MEETING: REGULAR MEETING OF THE VILLAGE BOARD
DATE & TIME: Monday, January 6, 2025 at 7:00 PM
LOCATION: Germantown Village Hall Board Room
N112 W17001 Mequon Road

- VII. **CONSENT AGENDA:**
 - A. MINUTES: December 16, 2024
- VIII. **UNFINISHED BUSINESS**
 - A. Jeff Osgood, Agent for Kwik Trip, Inc., and Ben Venue Properties, Property Owner, N112W18741 Mequon Road (former PNC Bank). Kwik Trip Convenience Store Relocation from W188N10963 Maple Road. Rezoning from B-3 to B-5 and Conditional Use Permit (CUP) applications.

Jeff Osgood, Agent for Kwik Trip, Inc., and Ben Venue Properties, Property Owner, is seeking approval of a Rezone, Conditional Use Permit (CUP), and site development/building/sign plans to allow for a *Convenience Food Store and Motor Vehicle Filling/Petroleum Service Station with Self-Service Carwash*. The site is located at N112 W18741 Mequon Road in the Lannon-Mequon Road Corridor and is located within a Groundwater Protection Overlay District.

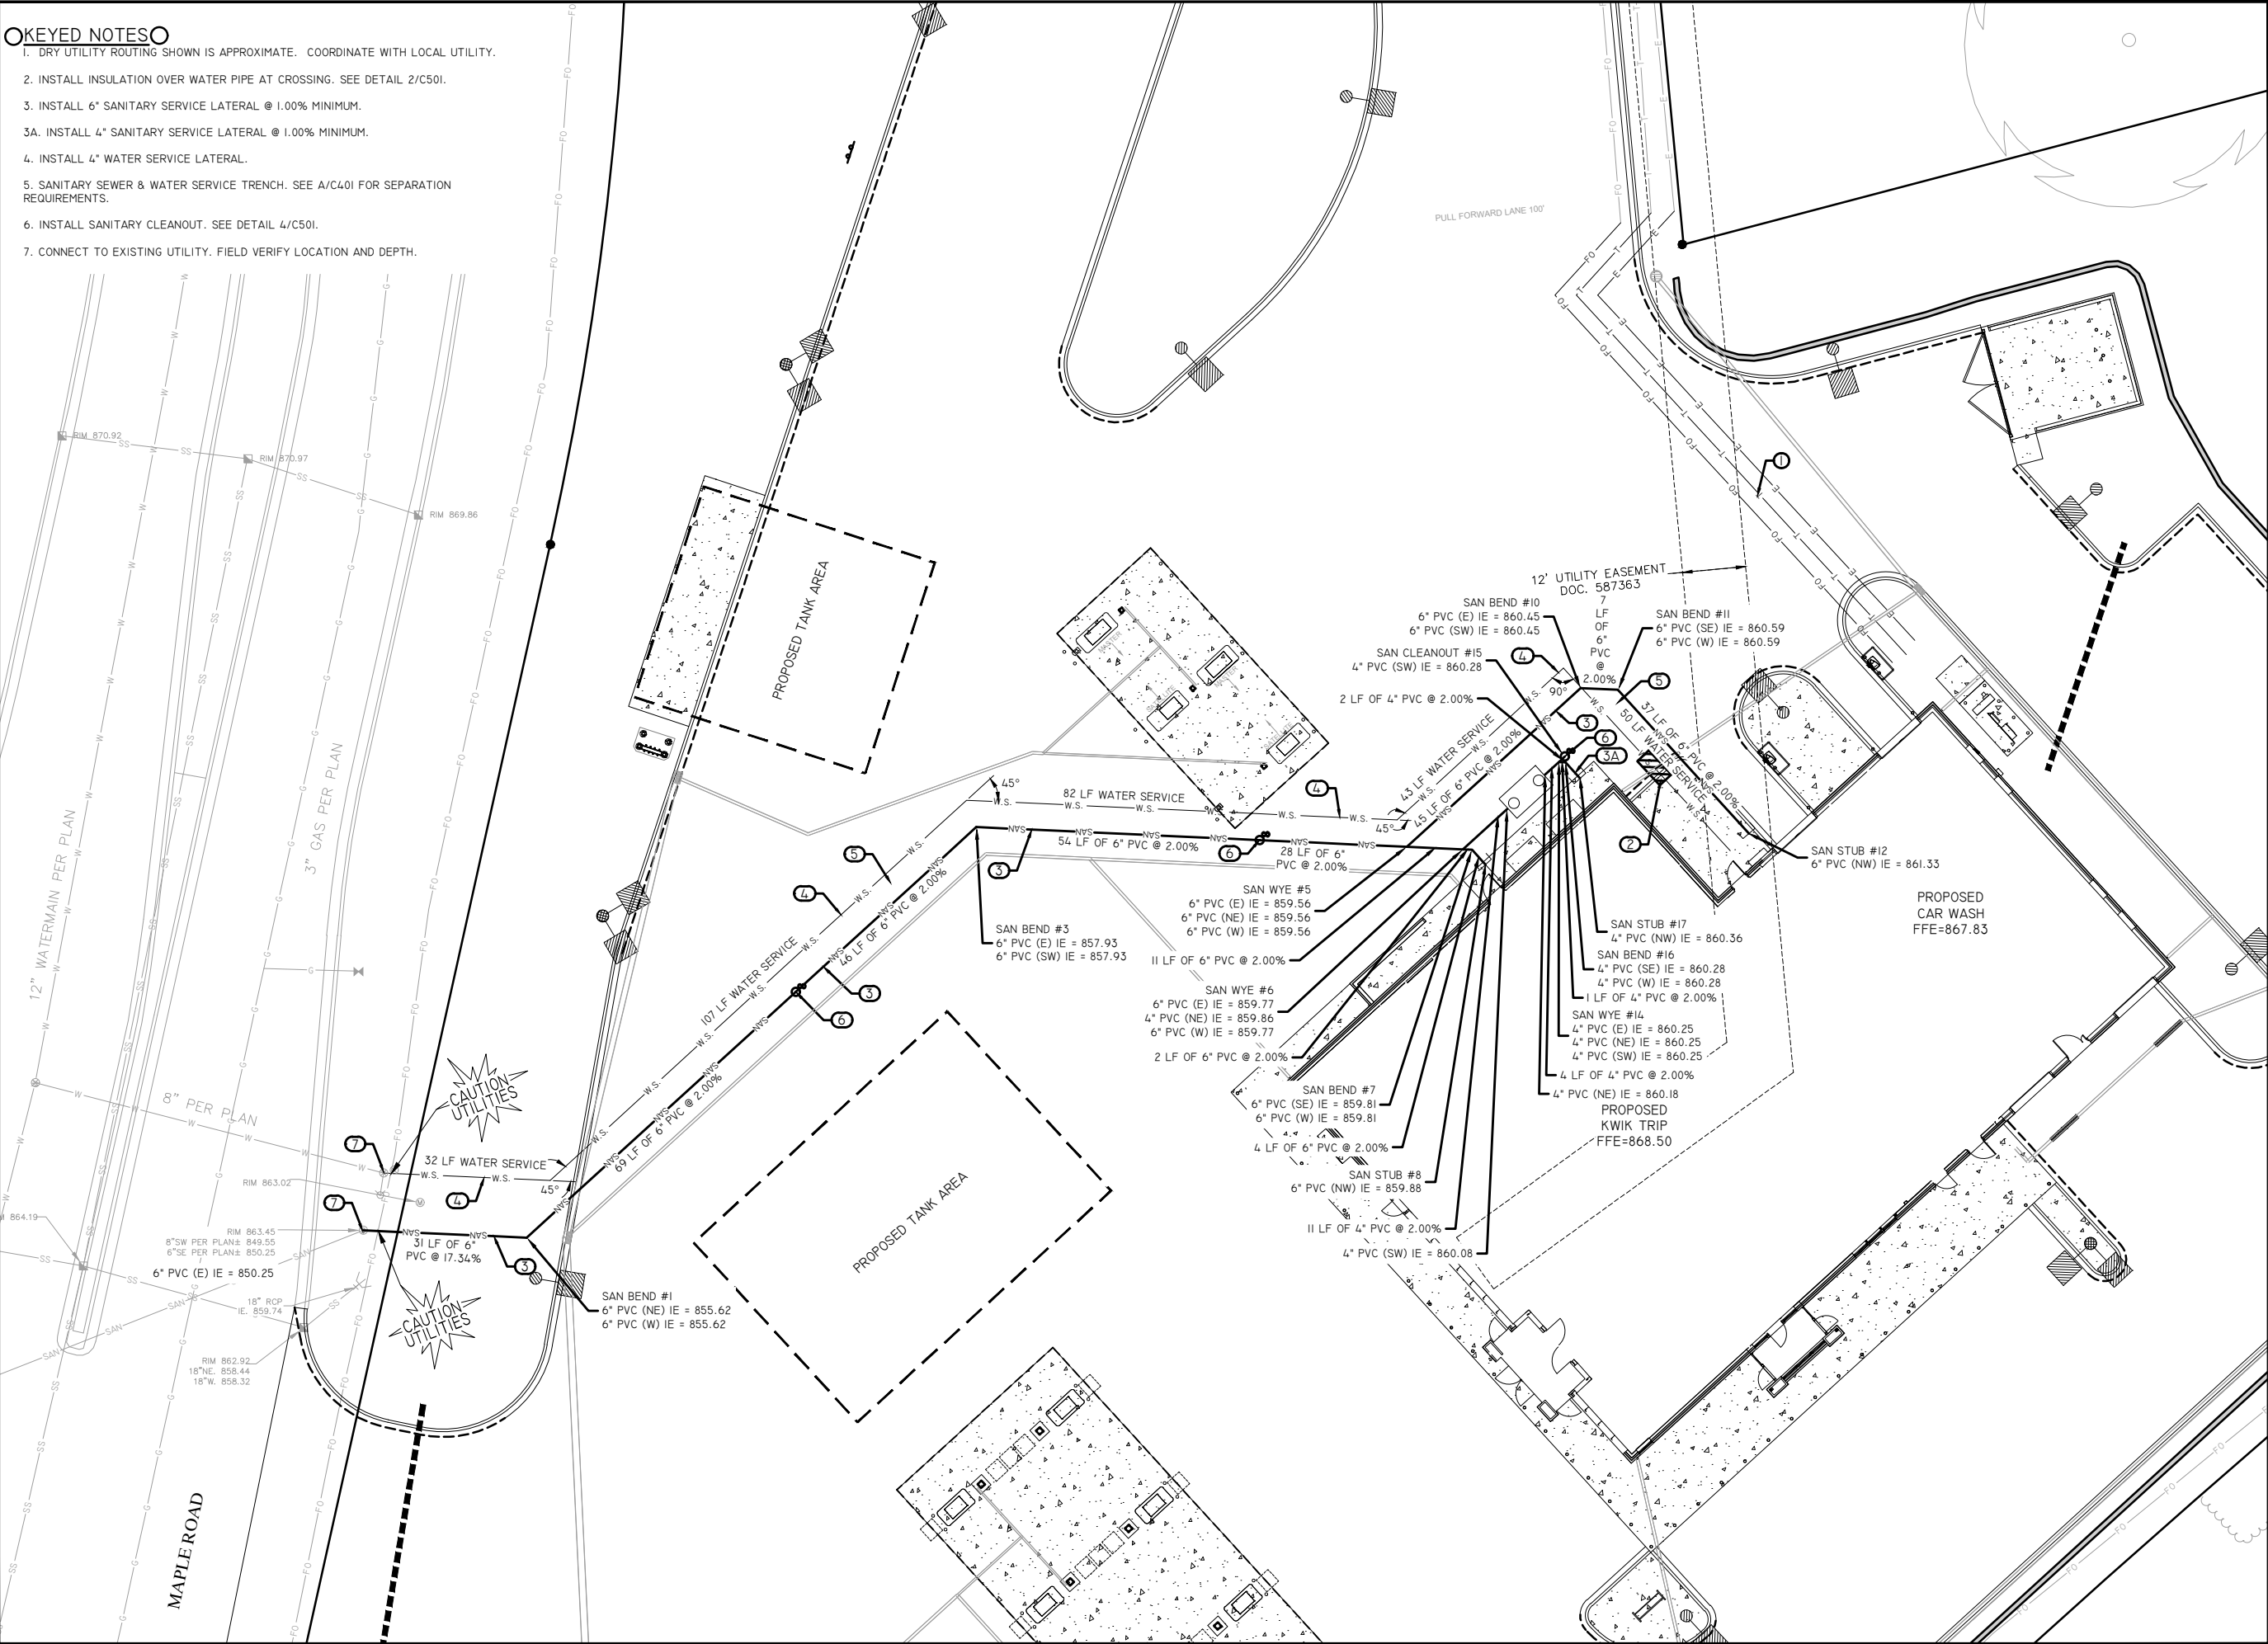
1. Sheet C400 – Add NOTE #8. install tracer wire per Germantown specification in the Development Handbook.
2. Sheet C400 – Shows 32 LF Water Service - Remove existing 6" or 8" gate valve. Install 8" x 4" reducer, install 4" R/W Mueller gate valve at ROW line
3. Sheet C401 – NOTES for Water Distribution System #6. – No station rods allowed
4. Sheet C401 – NOTES for Water Distribution System #7.

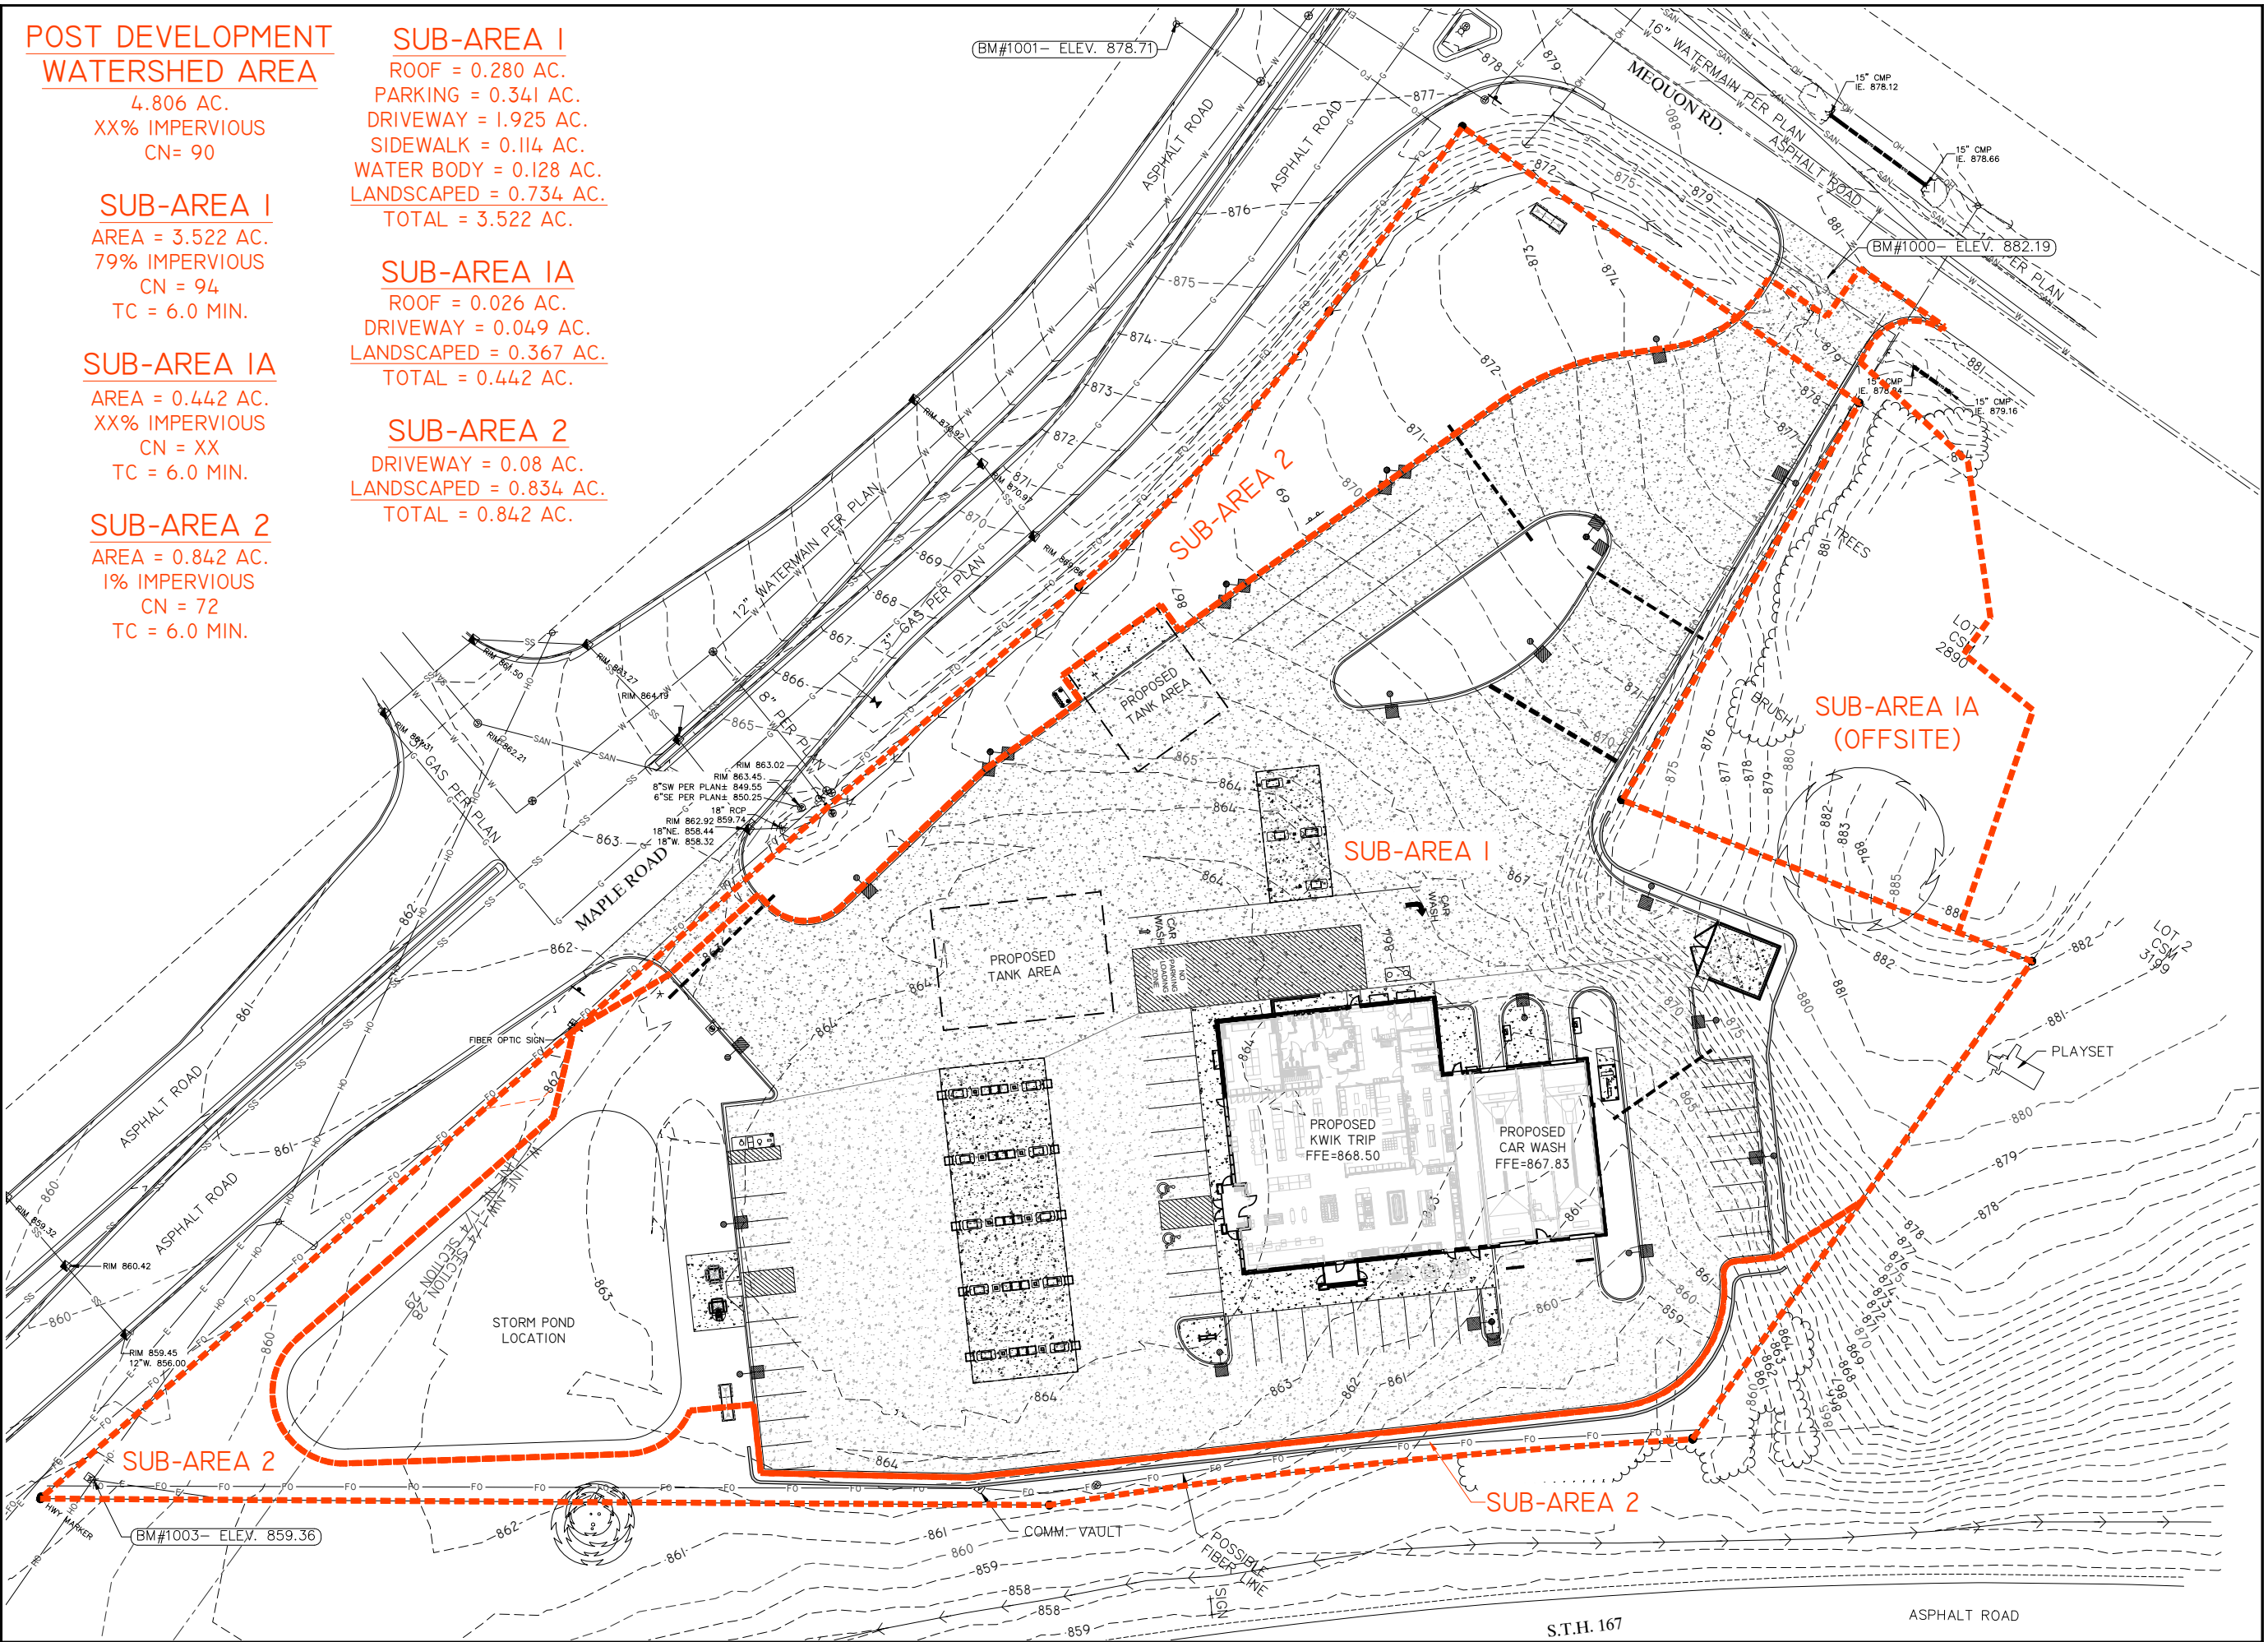
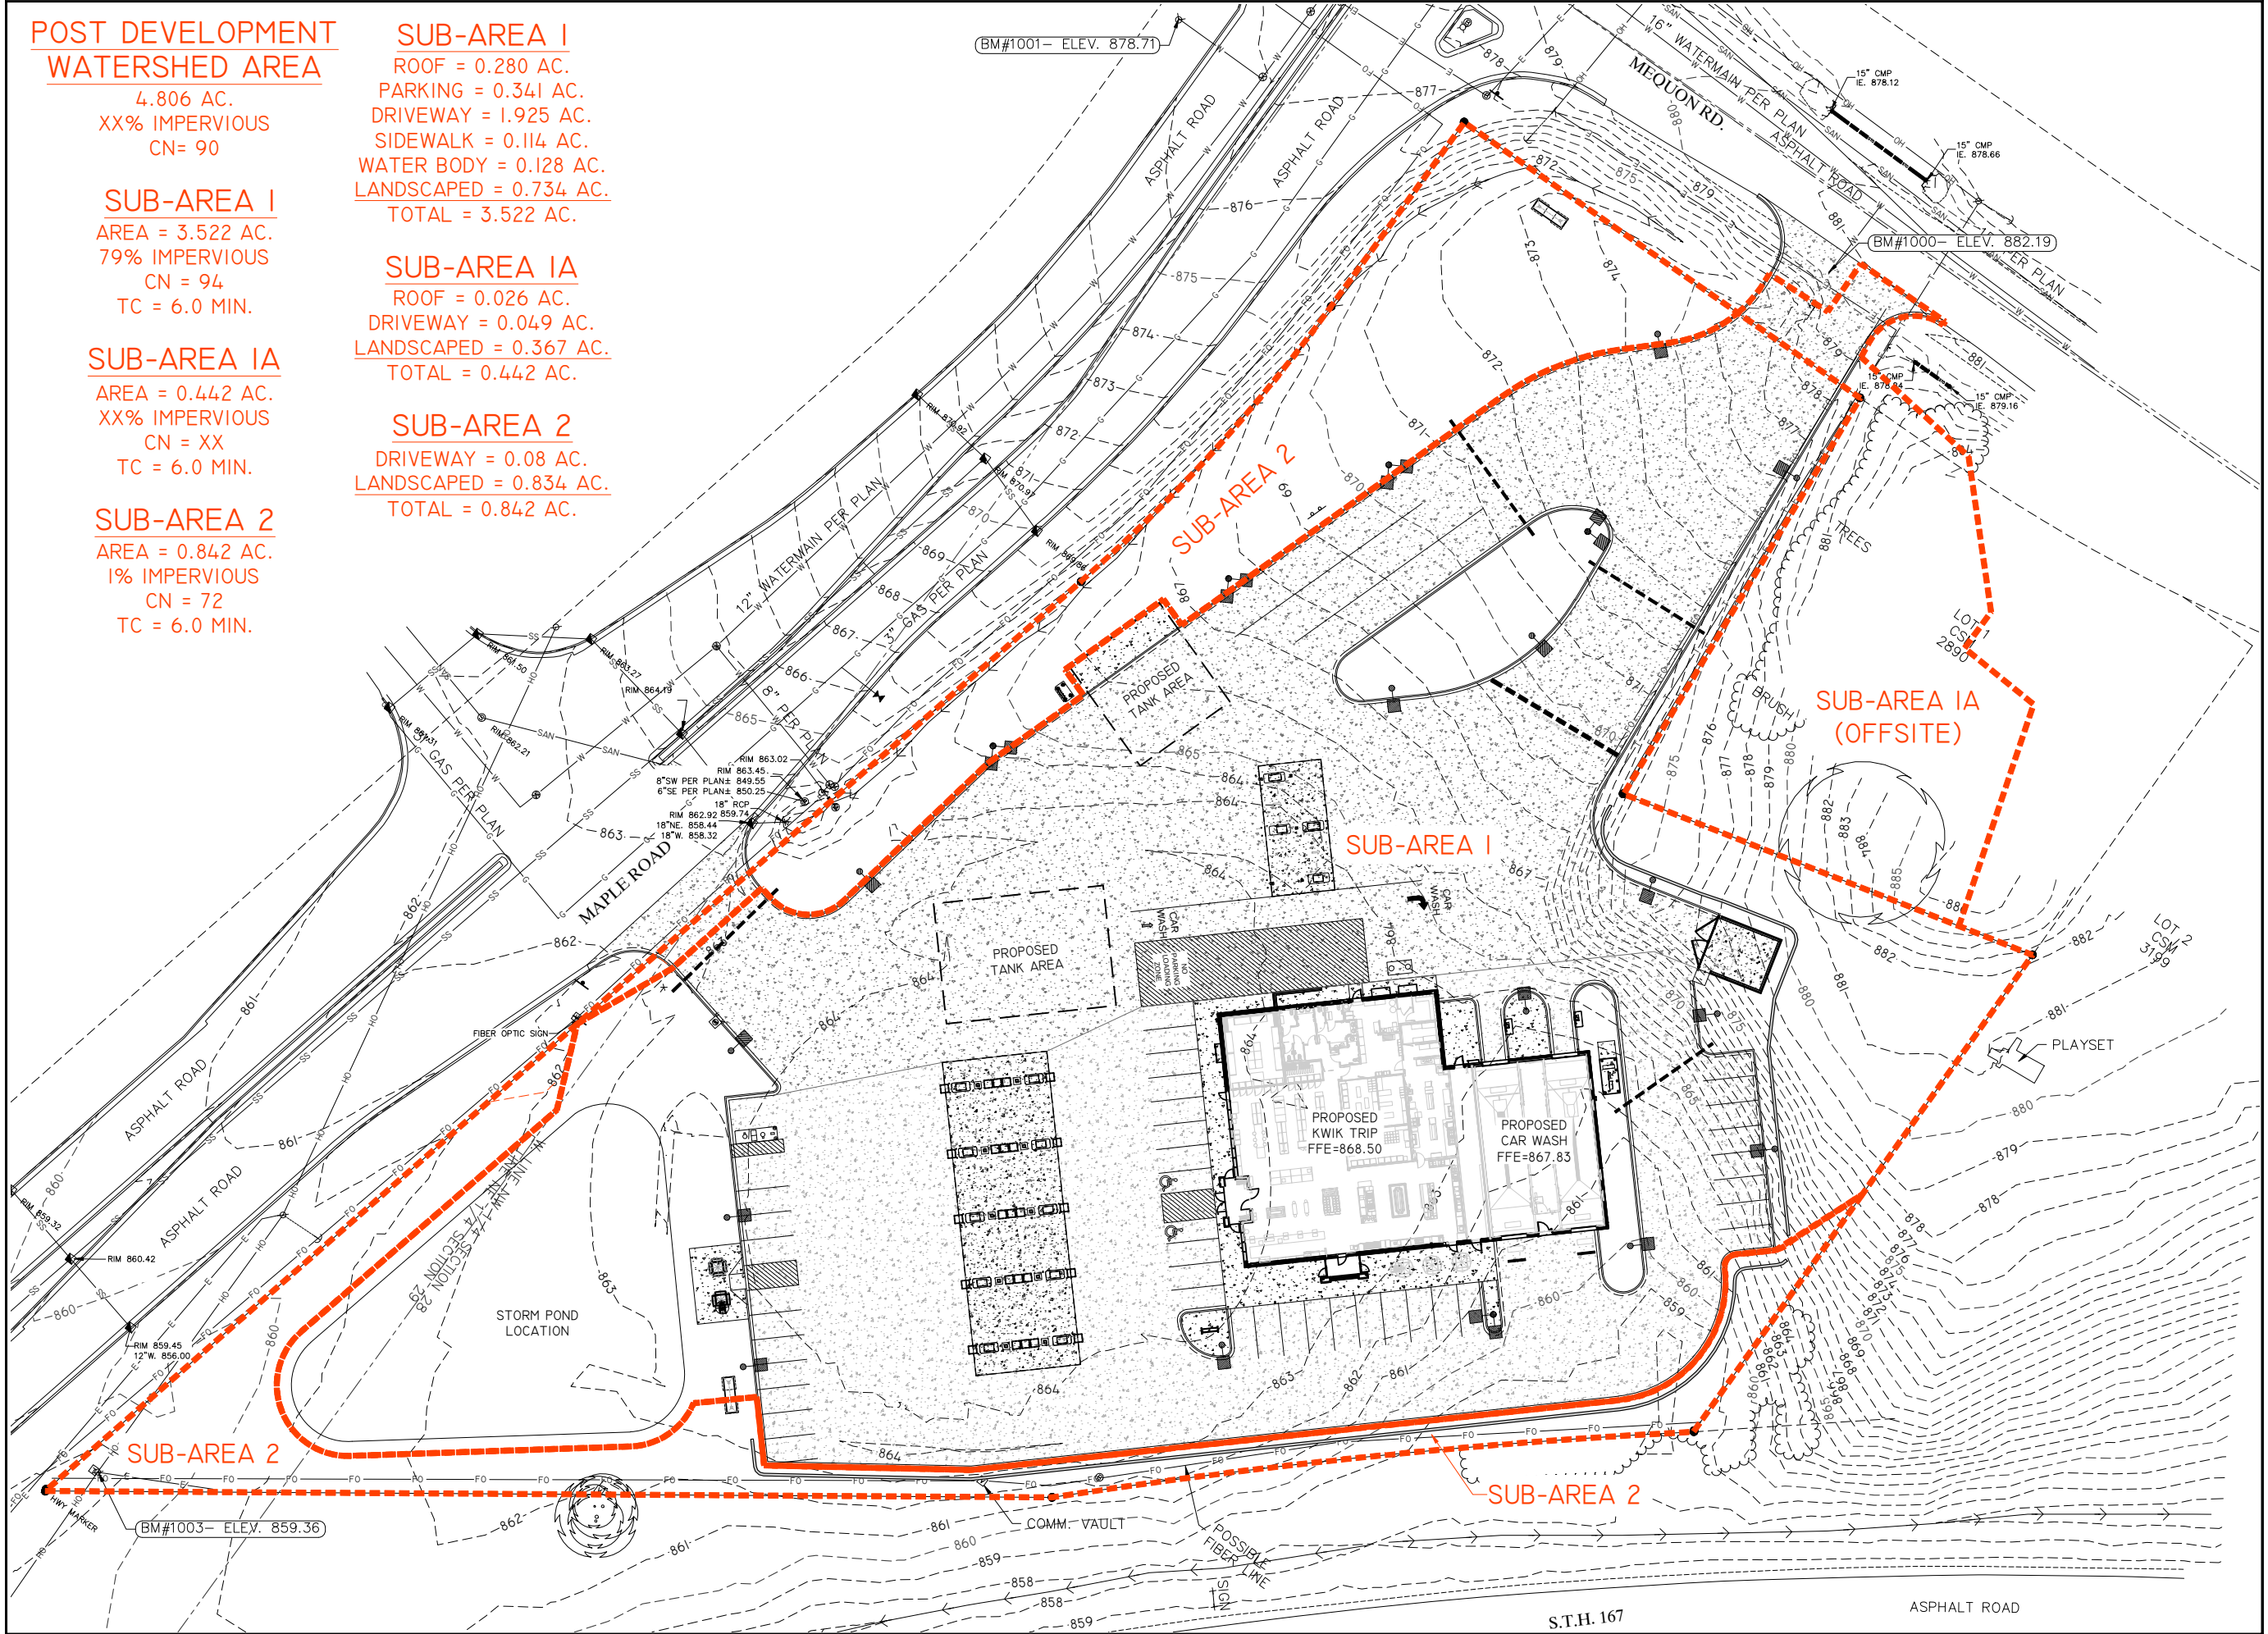
5. Show proposed grading on exhibit STM-1.
6. Show Tc paths on exhibit STM-1
7. Provide information on how the 100 year storm event will be routed to the basin. It appears some inlets will overflow offsite and not make it to the basin.
